Technical Service Bulletin

Subject: CRACKS ON LEFT AND/OR RIGHT RETRACTABLE HARDTOP QUARTER GARNISH	Bulletin No.: 09-019/24
	Last Issued : 03/26/2024

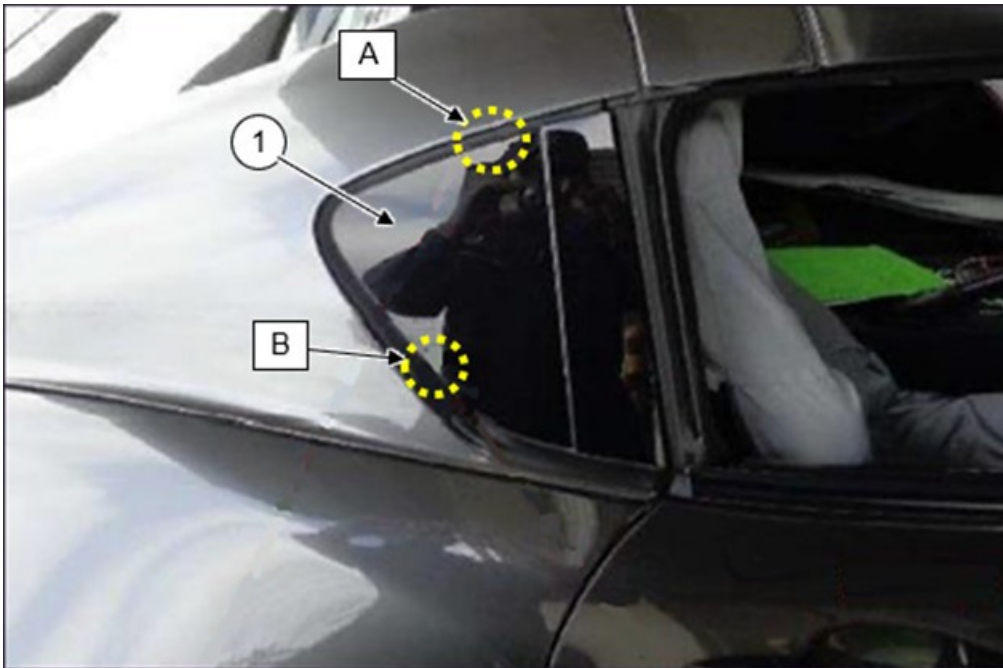
Some vehicles may exhibit crack(s) on the left and/or right side retractable hardtop quarter garnish (1). The molding material on the retractable hardtop quarter garnish may accelerate the deterioration of the quarter garnish, resulting in the cracks. To eliminate this concern, the molding material on the retractable hardtop quarter garnish has been improved.

1. Verify customer concern.
2. Replace the damaged quarter garnish with modified parts according to the instructions on MGSS online QUARTER GARNISH REMOVAL/INSTALLATION.
